Invitation for Bids Number: 16-32

Addendum 1

Date: June 10, 2016

350 CODDINGTON HWY NEWPORT RI

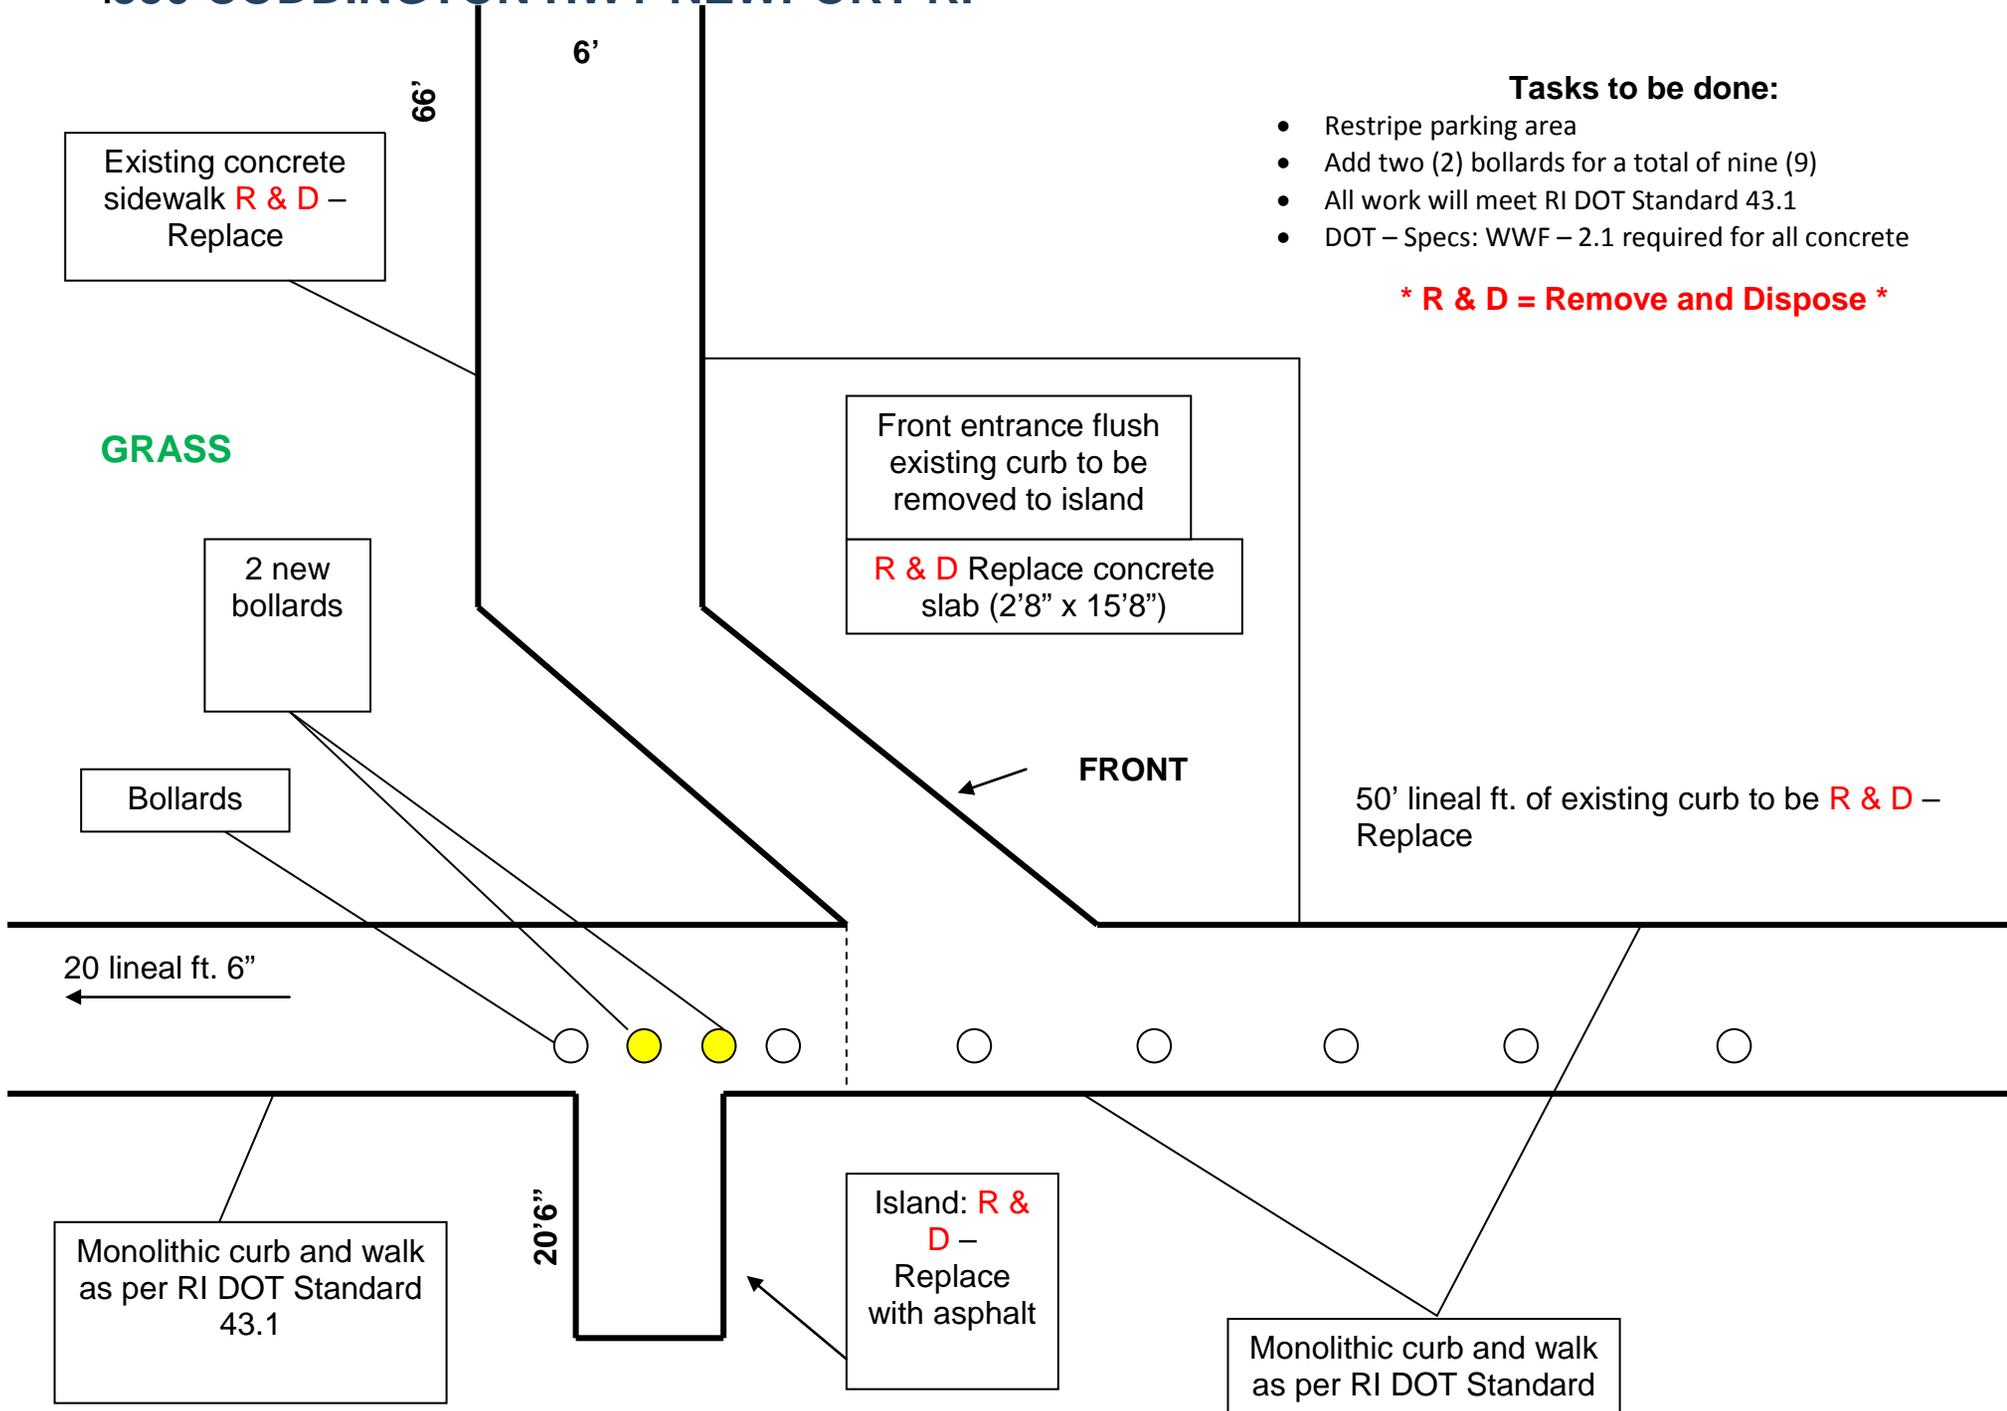
- Restripe parking area
- Add two (2) bollards for a total of nine (9)
- All work will meet RI DOT Standard 43.1
- DOT – Specs: WWF – 2.1 required for all concrete
